Bulletin No.: L03-007  
Release Date: 8/31/06  
Effective Date: Immediately  
Supercedes: N/A  
Completion Date:  
Sept. 15, 2006

# SERVICE BULLETIN

**Ride Name: HI-ROLLER PORTABLE MODELS AND  
CRAZY TRAIN PORTABLE MODELS**

**Mandatory Bolt, Nut, and Washer replacement schedule for track sections**

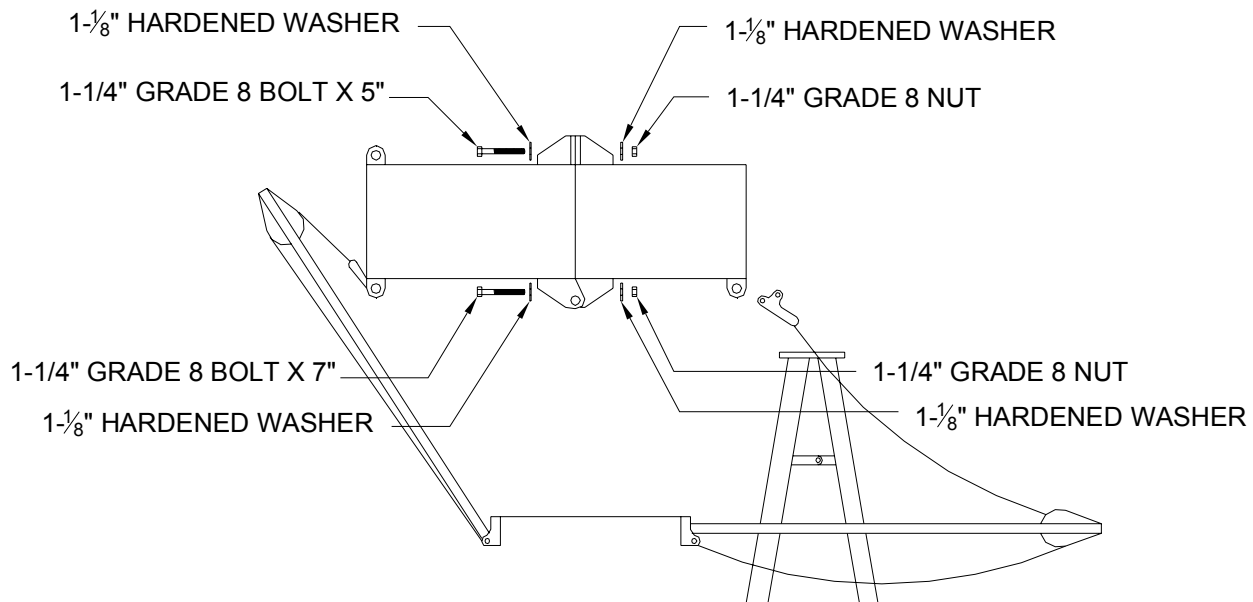
**Larson International Inc. has learned that the Grade 8 bolts, Grade 8 nuts, and hardened washers being used to fasten the two track sections together on the Crazy Train and Hi-Roller rides are being replaced with substandard bolts, nuts, and washers. There is reasonable concern that serious personal injury and property damage could result from failure of these fasteners.**

- 1. Remove all ten, 1-1/4" bolts, nuts, and washers currently being used to fasten the two track sections together.**
- 2. Replace with 1-1/4" Grade 8 UNC bolts, Grade 8 UNC nuts, and 1-1/8" hardened washers purchased from Larson International, Inc.**

- 3. All bolts and nuts must be dry torqued to 400 foot pounds with a torque wrench.**
- 4. Proper bolt tension must be checked daily with a torque wrench to 400 foot pounds of torque.**

- 5. All bolts, nuts, and washers must undergo a visual inspection each time the ride is erected checking for corrosion, thread damage, bending and cracking. If any corrosion, thread damage, bending or cracking is seen or if excessive torquing is required to remove the bolts and nuts they must be replaced immediately.**

- 8. The entire set of bolts, nuts, and washers must be replaced annually after initial replacement.**
